Exterior Renovations
at

Cascadian Apartments 15517 NE 12th St., Bellevue WA 98007

February 23, 2024

ADDENDUM NO. 1

SHEET NO.
A562

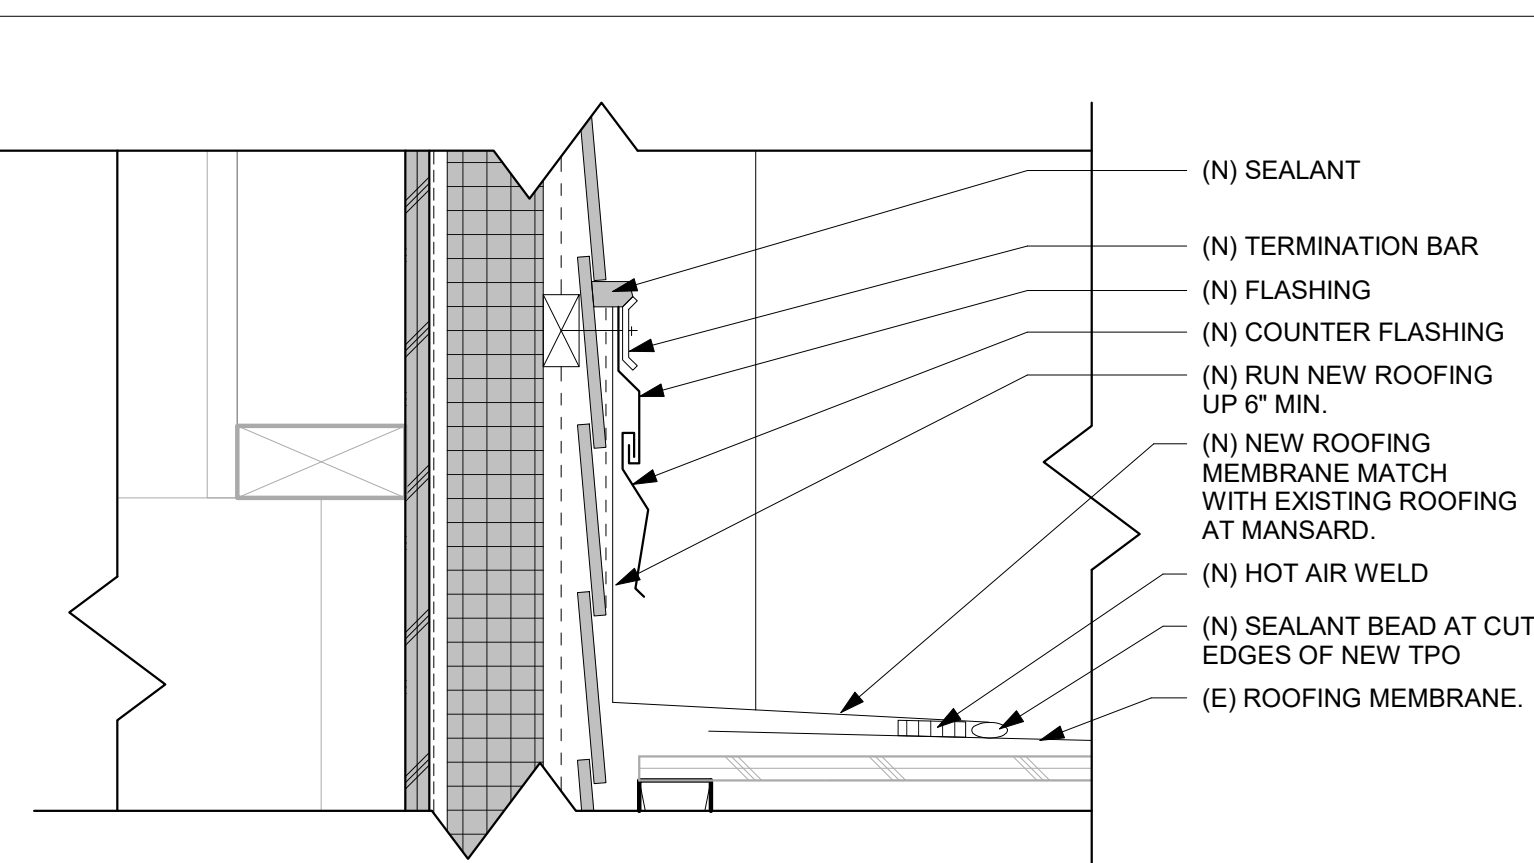
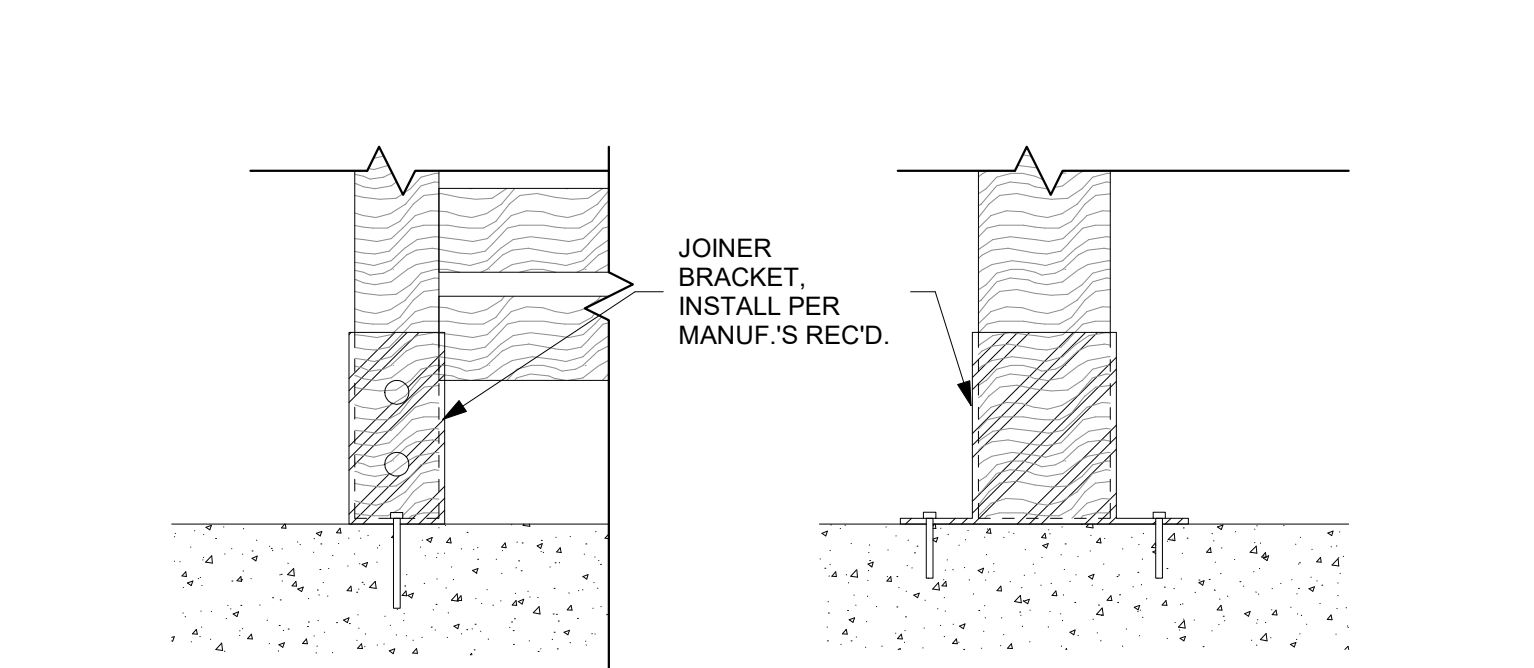
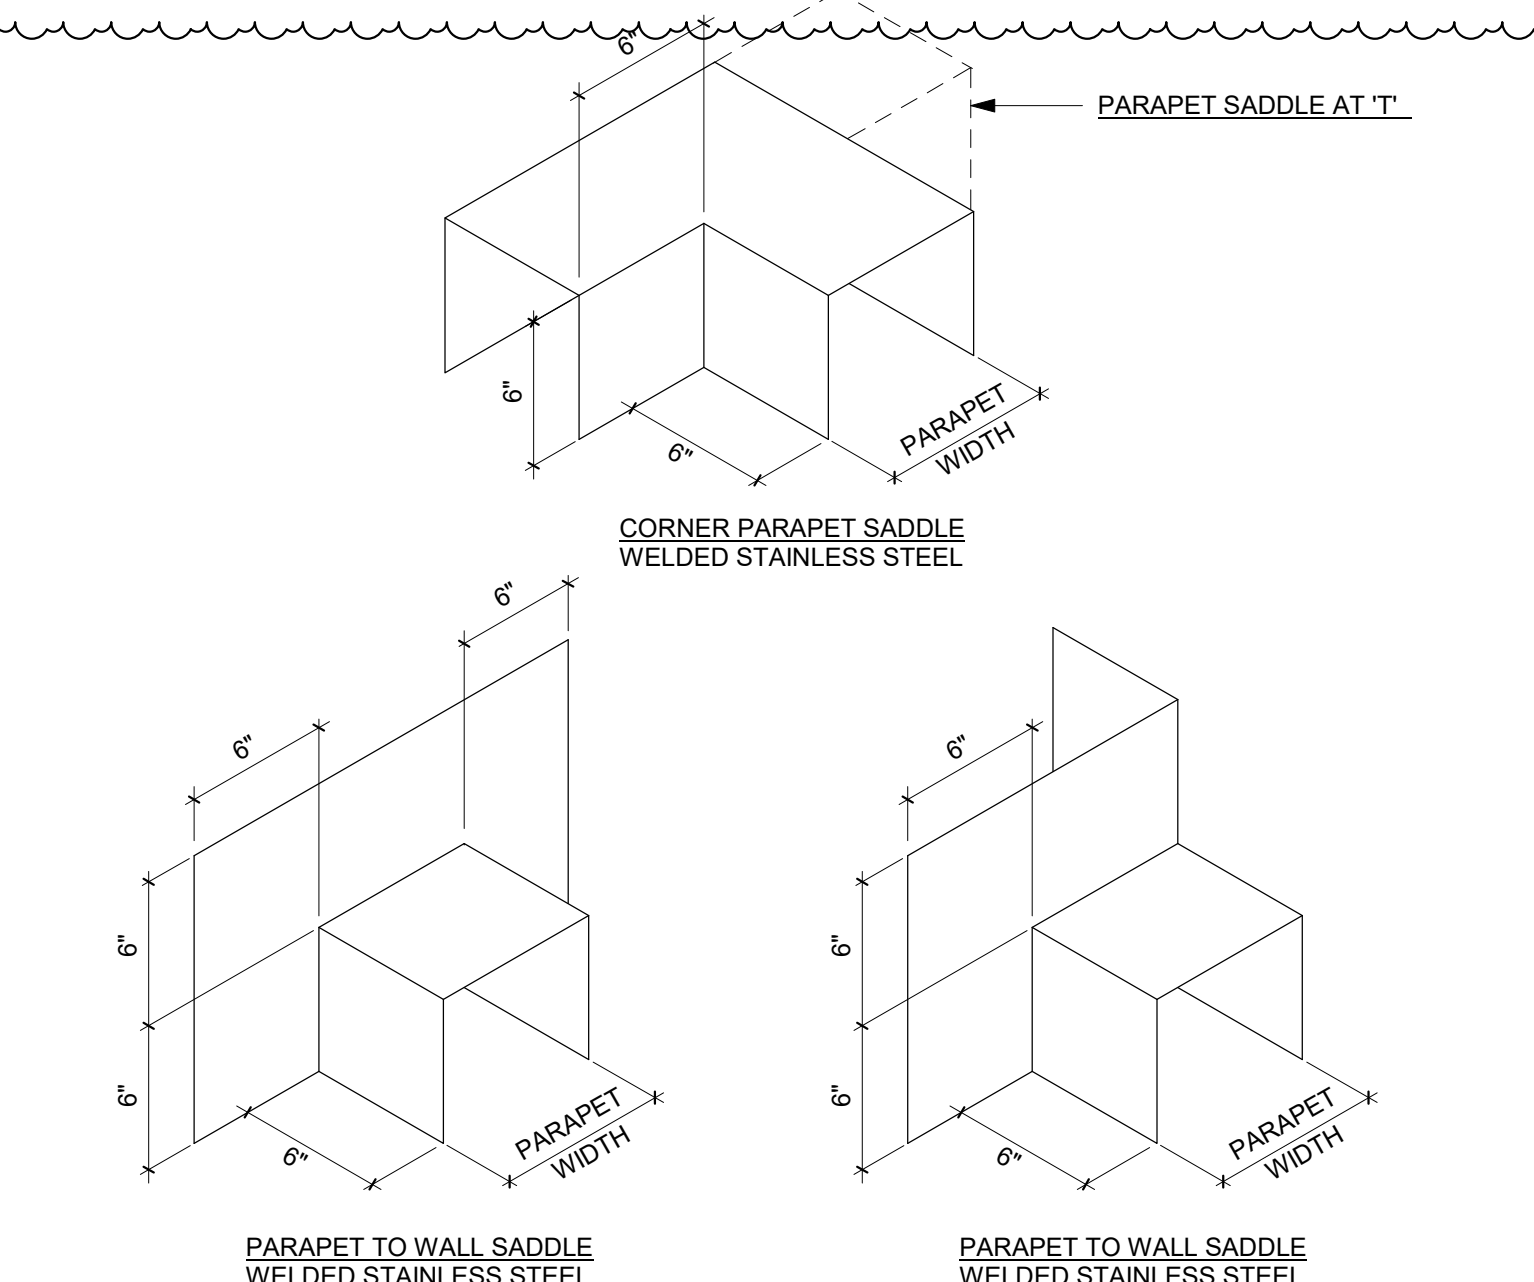
Q. 7. Existing privacy wall at decks – What is the material and design intent?

A. Existing privacy wall at decks to be removed. Install new privacy wall wood slat screen. Design intent: Wood slat surface mounted screen. See details 6, 6a, and 9 on sheet A562 for field fabricated privacy screen. Other manufacturer accepted: Enclo Tiaga wood surface mount privacy screen. Product's website: <https://encloscreens.com/product/tiaga-slatted-wood-freestanding-or-surface-mounted-privacy-screen-kit-1-panel-735in-h-x-36in-w-188.html>

610 WINDOW TYPES - VINYL

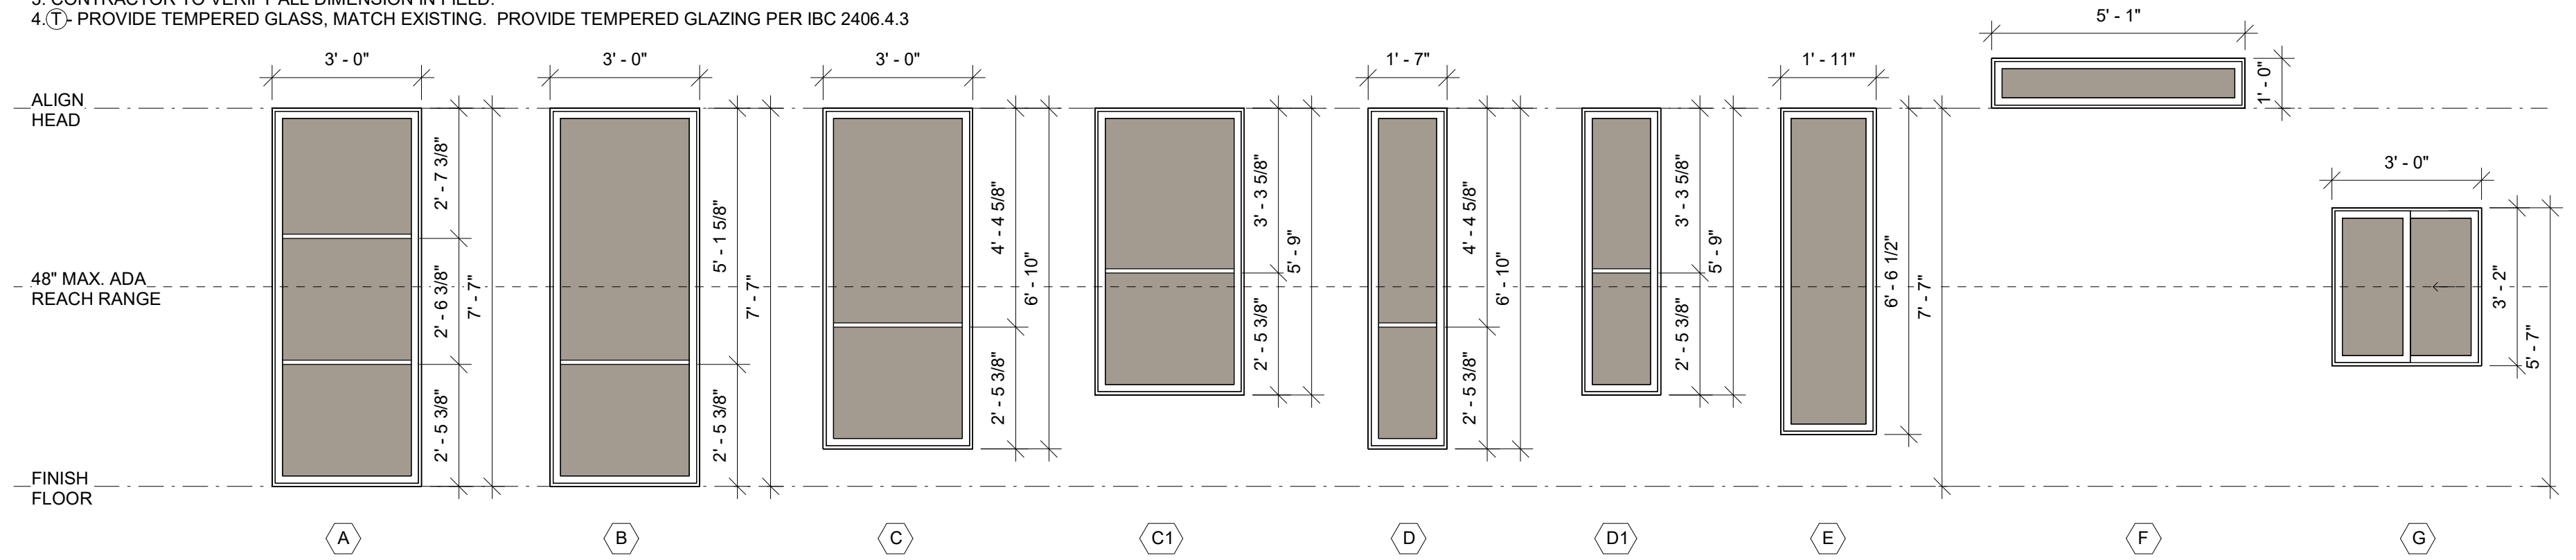
Q. 1. Windows and Sliding Patio Doors- These are not scheduled to be replaced. Do they need to be removed in order to flash?

ADD-ALTERNATE 1: Provide new windows and new sliding doors to Building N and Building P. See sheet A600 for door and window schedule. See section 08 00 00 on sheet G004 for product specifications and manufacturers. See attached revised bid sheet with ADD/ALTERNATE bid item to be filled in as a required line item in the bid. Because the labor to install the existing windows is already in the base bid, this item includes only the added material costs to provide the new windows and sliding doors.
